ADDENDUM NO. 04

PROJECT NAME: Alamodome Field Level Locker Room Renovation
PROJECT NO.: 11010
DATE: May 27, 2011

PARTIAL THIRD FLOOR PLAN
 SCALE: 1/32" = 1'-0"

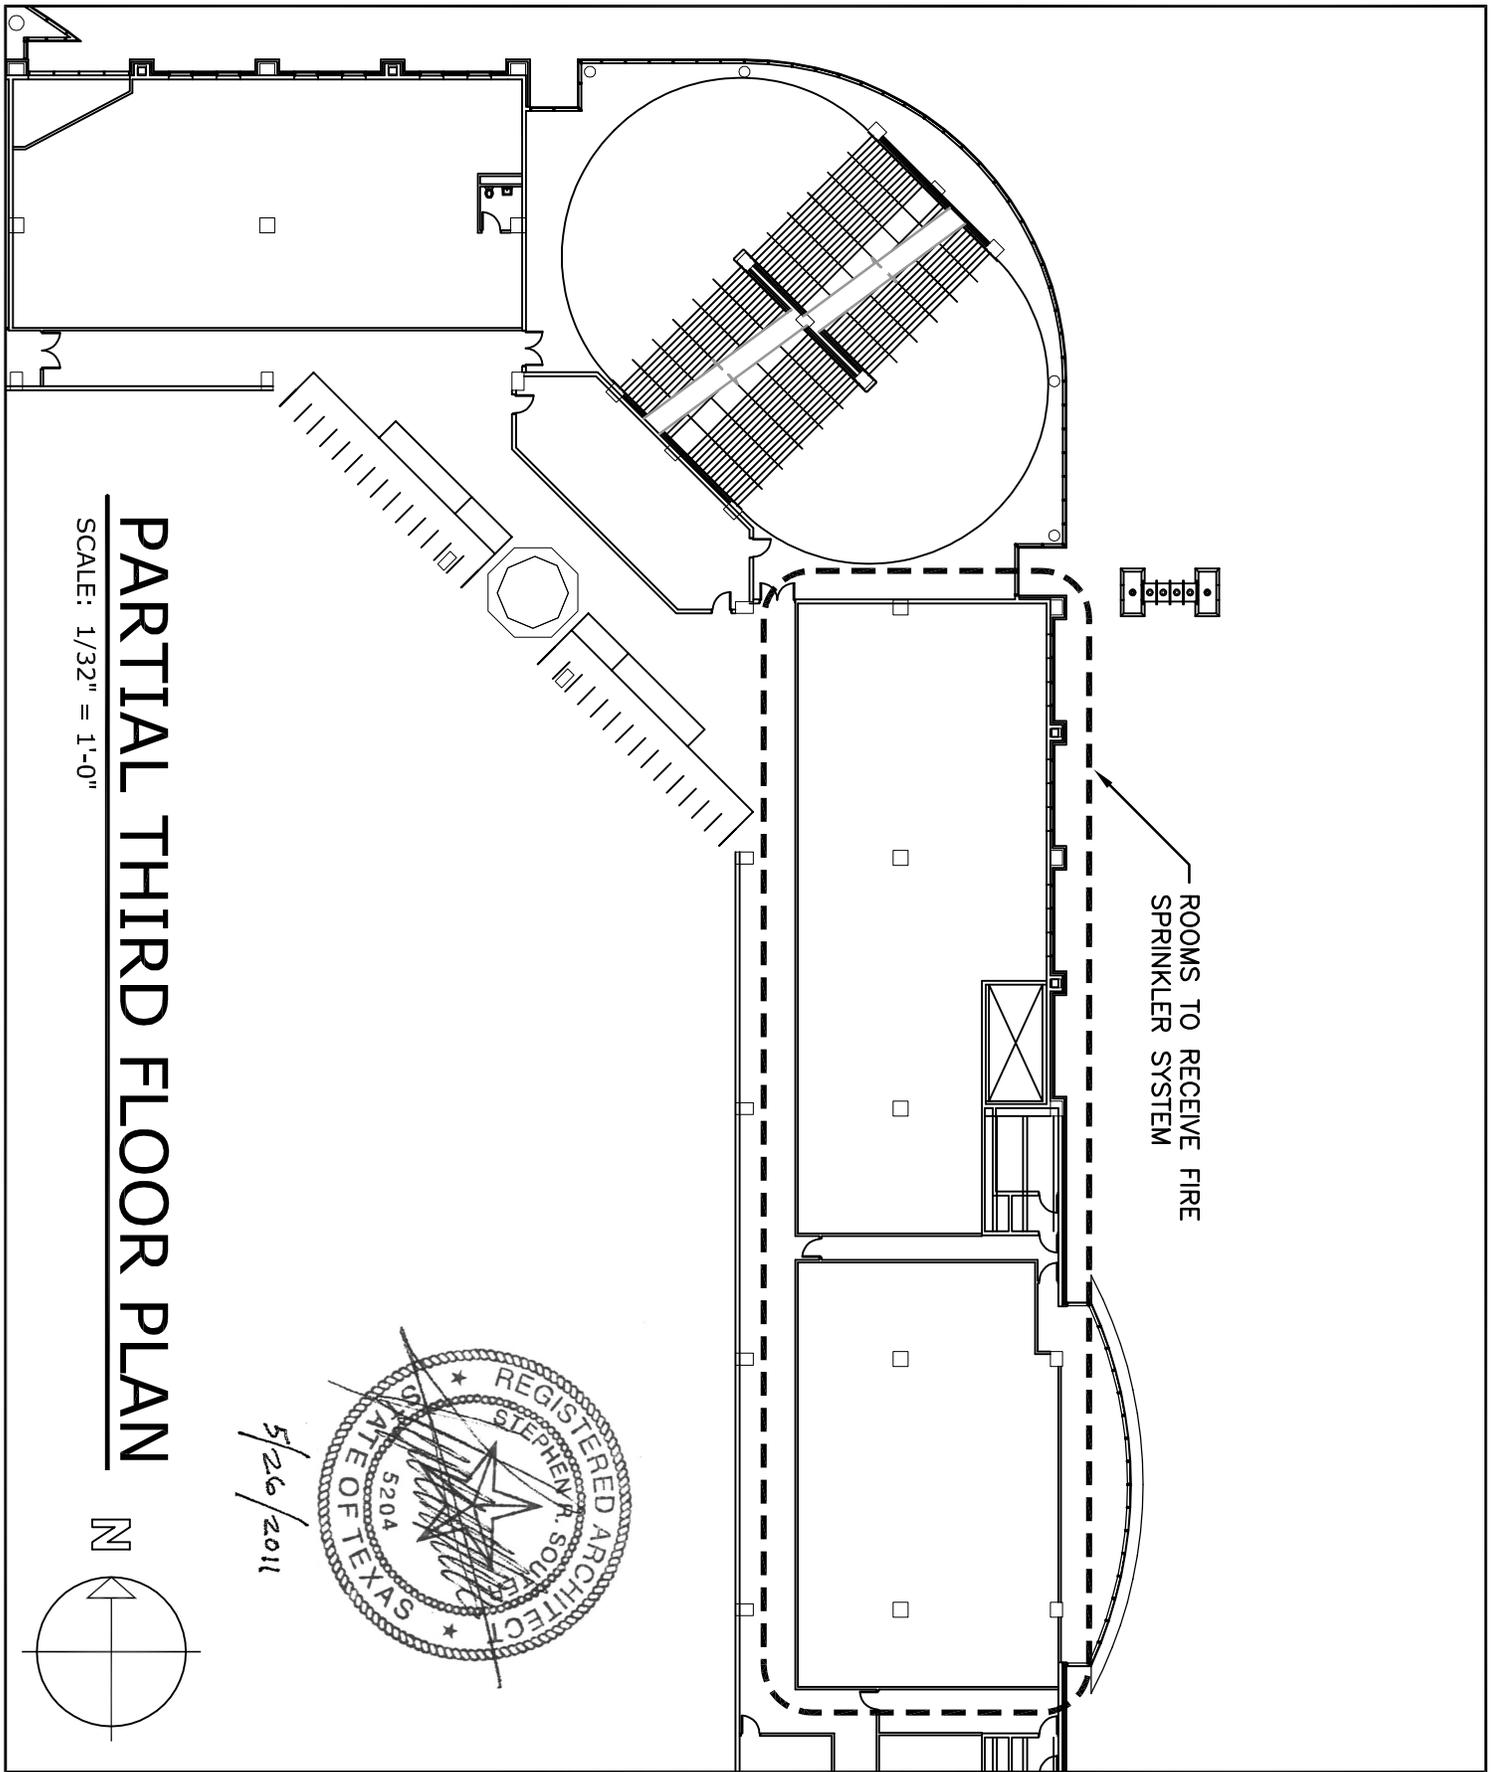
ITEM NO. 2 CLARIFICATION, PROVISION OF FIRE SPRINKLER/ALARM SYSTEM IN EXISTING ROOMS ON THE THIRD FLOOR:

- A. The contractor shall provide and install all necessary and code-required materials for the installation of an overhead fire sprinkler system in the indicated rooms. The existing rooms are to become general storage rooms (no rack storage), requiring an ordinary hazard, Group 2 level of coverage. The rooms have exposed-structure ceilings. Sprinkler heads (preferred upright, plain brass is acceptable) shall be rated and spaced per standard NFPA and International Building Code requirements. The piping system shall be connected to the nearest existing main that is of adequate capacity (wet-pipe). If no sprinkler main is adequate, the supply shall come off the nearest floor-riser supply main. Pipe shall be schedule 40, black steel.

- B. Wall-hung fire extinguishers (ABC Multi-Purpose Dry Chemical-20-lb.) shall be installed at each exit door.
- C. The contractor shall provide and install all necessary and code-required materials for the installation of fire detection devices (heat/smoke detectors, horn/light annunciators), connected to the existing master fire panel, similar to other existing areas. Also, verify exit sign/lights and provide if necessary at each exit door.

- D. Any existing Piping or equipment may be reused if possible. All existing piping and equipment that cannot be used shall be removed.
- E. Reference General Fire Sprinkler Requirements on Sheet P101 for additional requirements. See attached sketch for locations of rooms.
